STAFF REPORT – SUBDIVISION (SKETCH PLAN)
PREPARED BY: Shawn Putnam
DATE: October 23, 2026

Project Name: Pine Tree Subdivision

Location: 1319 Lakeshore Drive

C-103

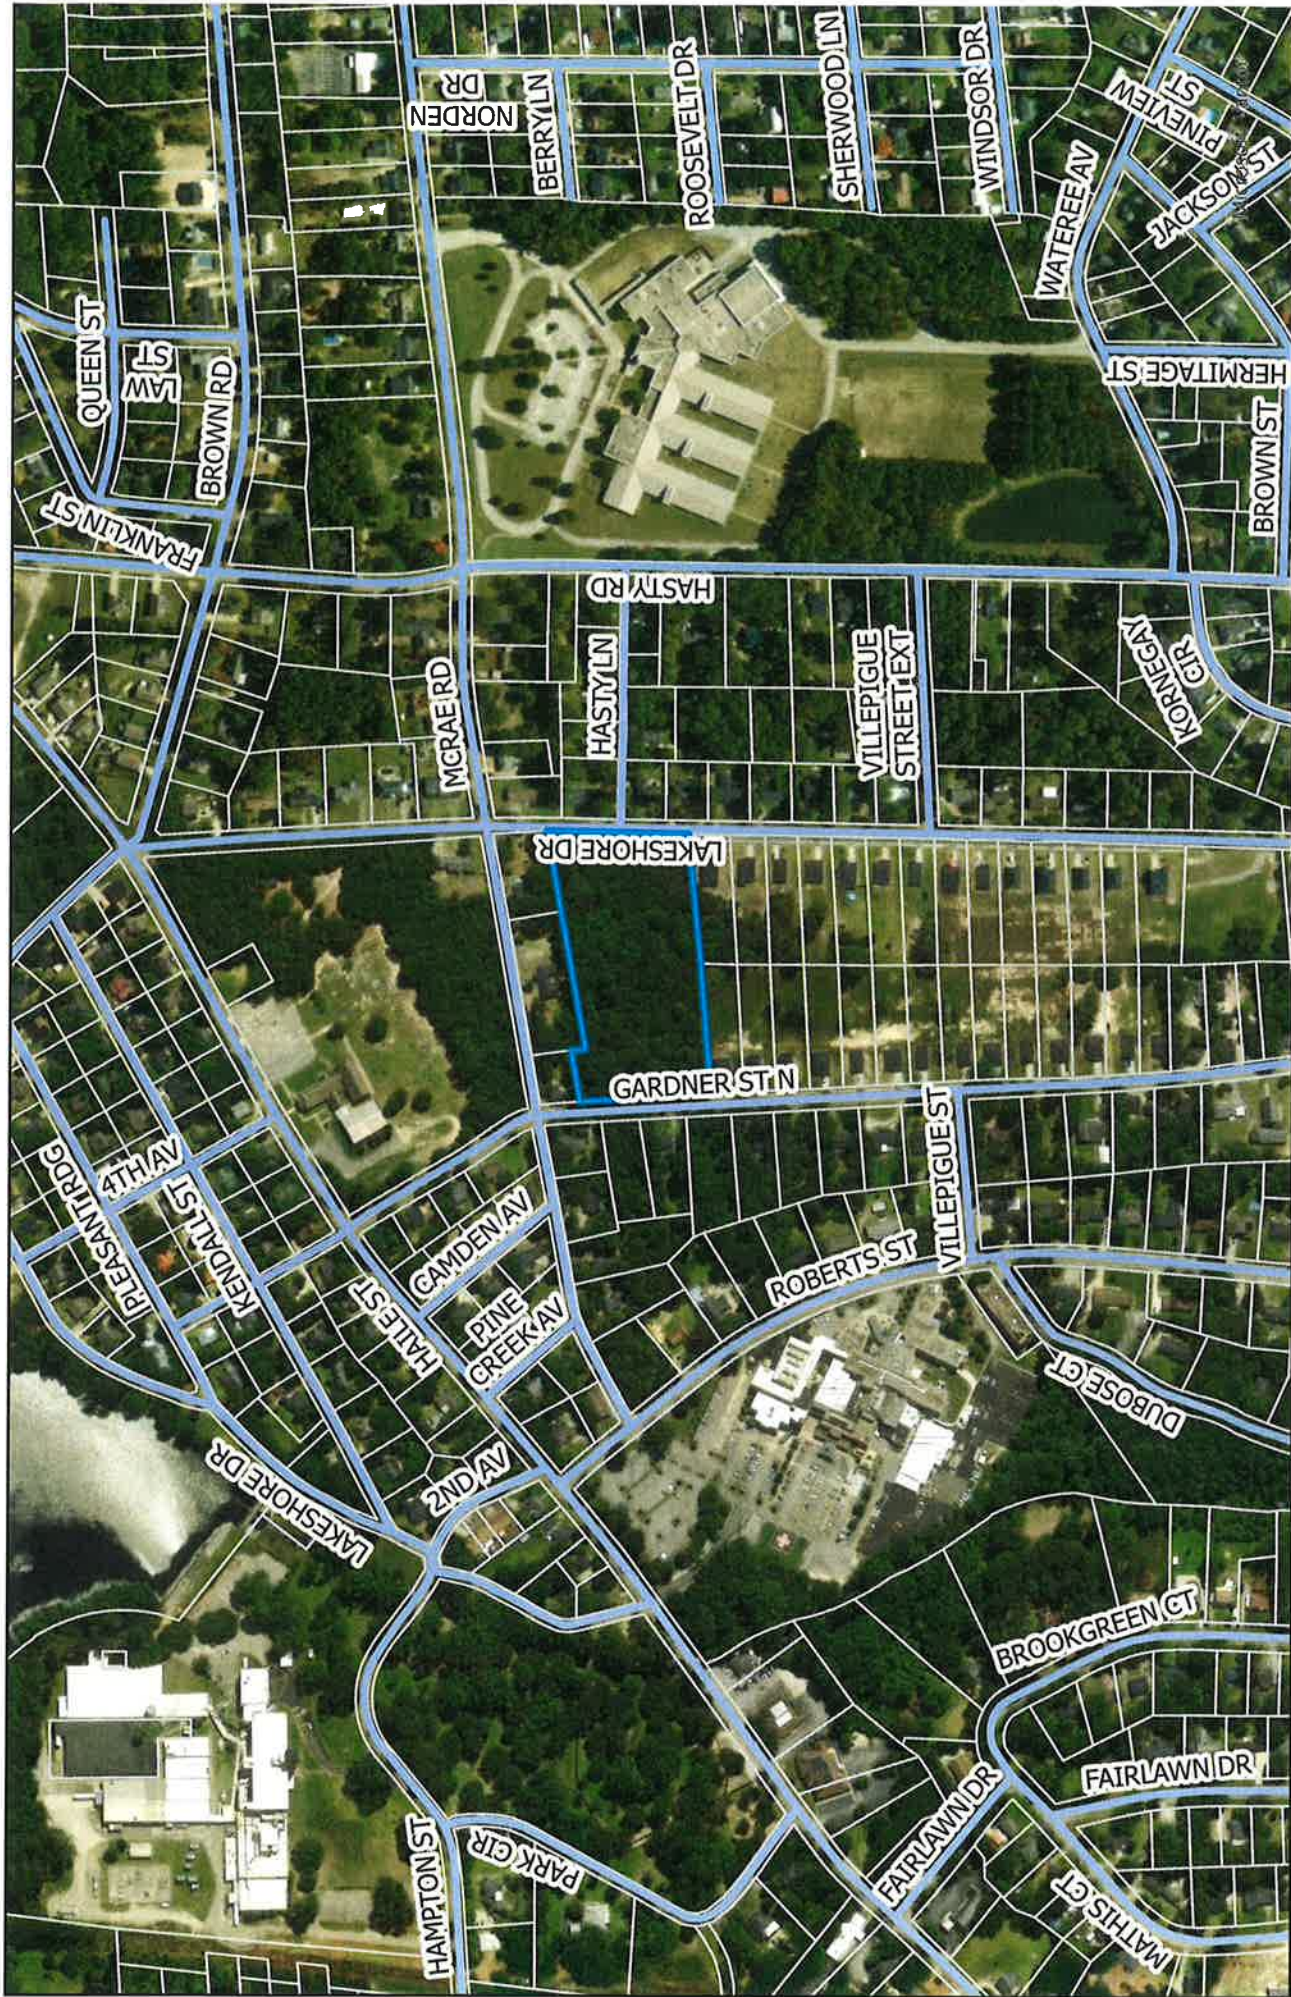
156.41	General Site Design Standards	OK
156.42	Streets	OK
156.43	Curb and Gutter	OK
156.44	Signage and Names	N/A
156.45	Easements	OK
156.46	Blocks	OK
156.47	Lots	OK
156.48	Sidewalks	OK
156.52	Sanitary Sewer and Water Supply Systems	Need additional water/sewer service connections
156.53	Fire Hydrants & Fire Department Access	OK
156.54	Surveys and Markings	OK

Public Works: Drawings currently show one water and sewer service connection per structure. A separate water and sewer service connection is required for each dwelling unit.

- Revise plans to provide a water and sewer service connection for each dwelling unit.
